**ANNEXURE A - NGAI TAHU PROPERTY LIMITED & NGAI TAHU JUSTICE HOLDINGS
LIMITED'S SUBMISSION AND FURTHER SUBMISSION**

FORM 5
SUBMISSION ON PROPOSED QUEENSTOWN LAKES DISTRICT PLAN

1. This is a submission on the Proposed Queenstown Lakes District Plan.

Permeability map Queenstown- extend this map to wider area

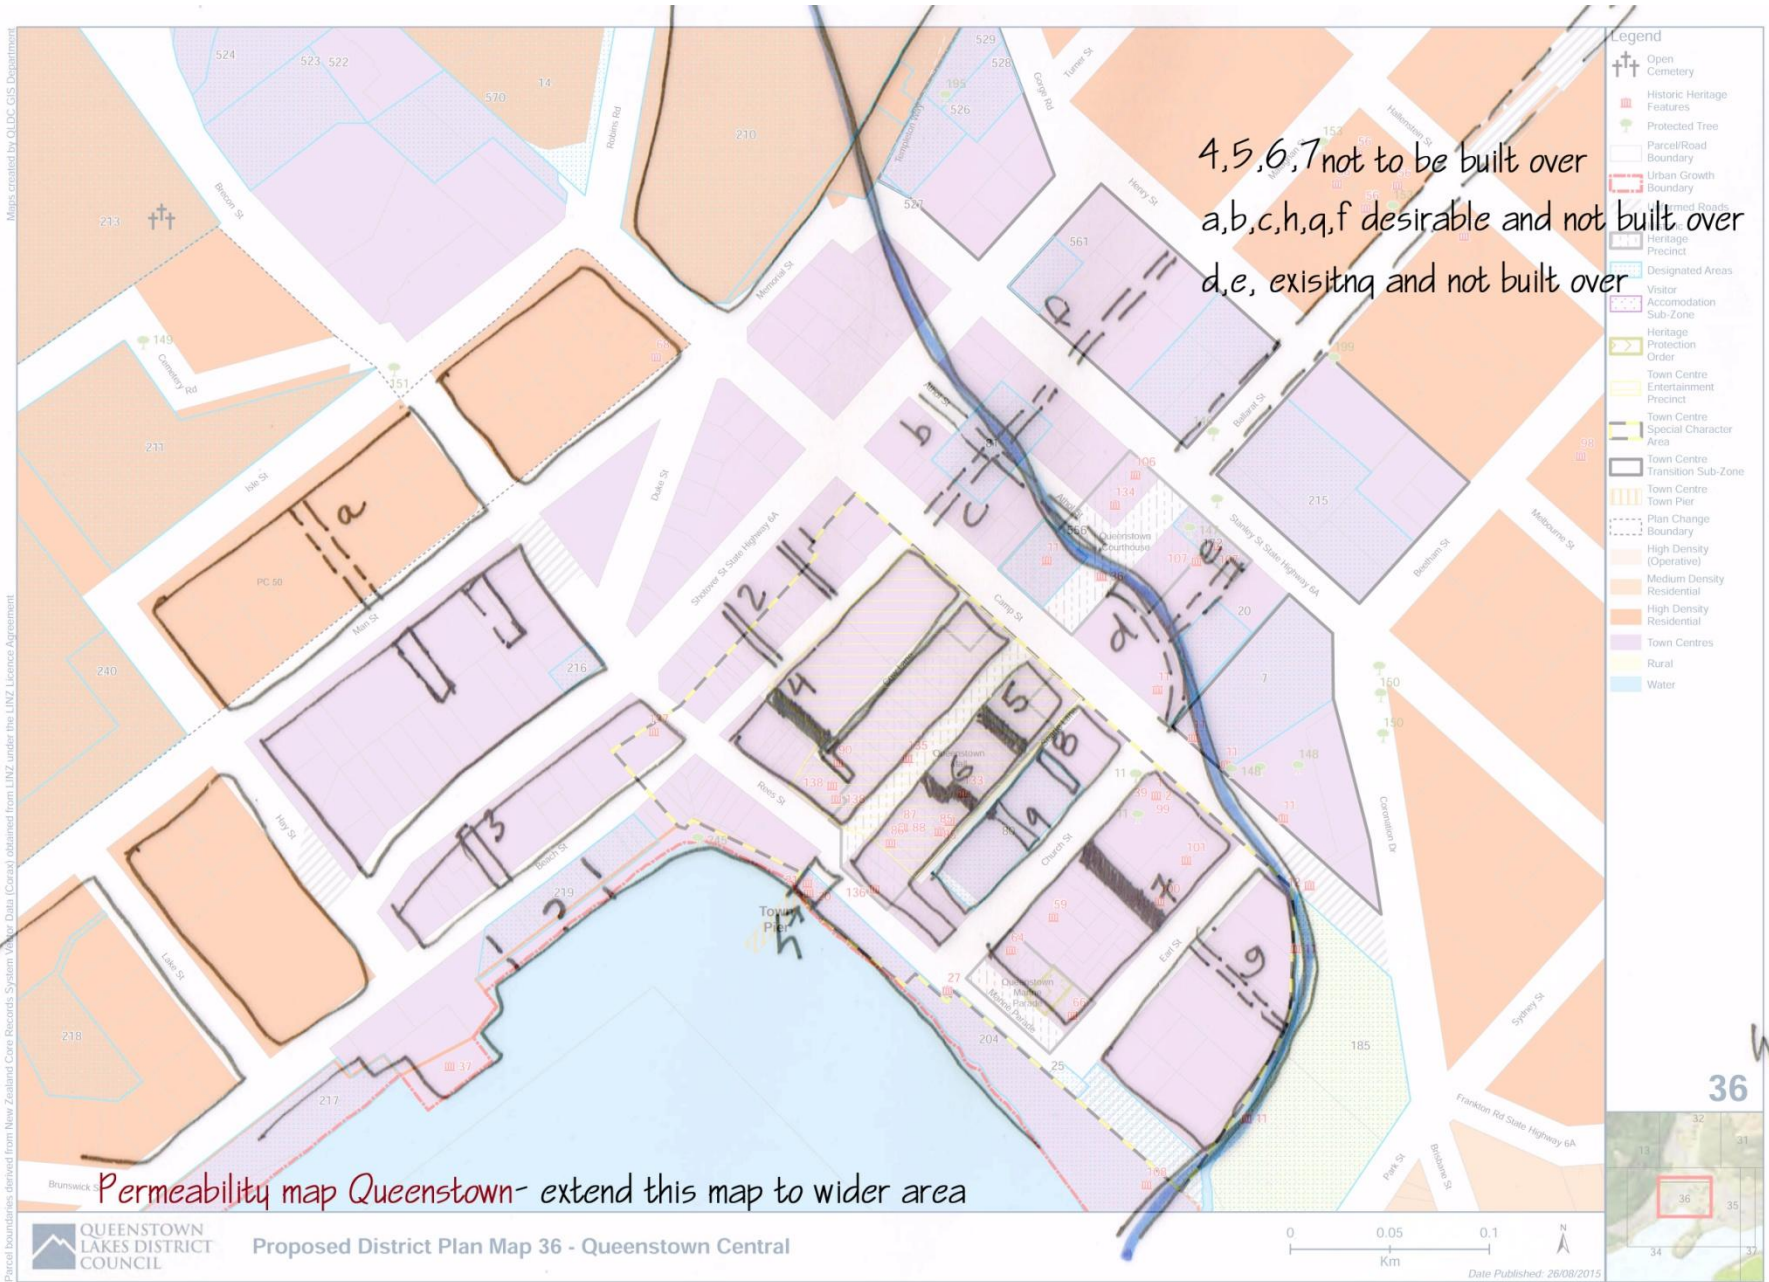
| 12.5.8.1 Provision of pedestrian links | Insufficient size of map, do not support in this format | <p>Pedestrian links, open to the sky are a very important part of Queenstown character and should be sought and extended into the fabric of town centre and mixed use zone wherever possible.</p> <p>Map should show desired locations., not just existing ones, and fails to show important links that have been introduced since last map- i.e. Ngai Tahu courthouse area and opening up of Horne creek.</p> <p>Horne creek should be in this as well.</p> <p>Need to rename this a "permeability " map.</p> | <p>Note: Nothing in rules 12.5.8.1 and 12.5.8.2 shall prevent a building or part of a building being constructed at first floor level over a pedestrian link - delete</p> <p>12.5.8.1(additional) Pedestrian links should be open to the sky. Introduce better "permeability map" as shown that encompasses gorge Road retail and expanded town centre and show all existing and desired links.</p> |
| 12.5.8.1 | Don't support map | <p>Need to rethink map , - look for future pedestrian linkages that will be required, not just in this zone but all town centre, mixed use zones. Call it a "permeability map". This is too restrictive- shows erosion of former links in to covered in ,ghastly malls. We don't want that. There could be incentives- i.e. height etc for linkages offered in desired areas.</p> | <p>Replace figure 1</p> <p>Extend map and look at future linkages, not covered in links but walking permeable links through entire zone.</p> |
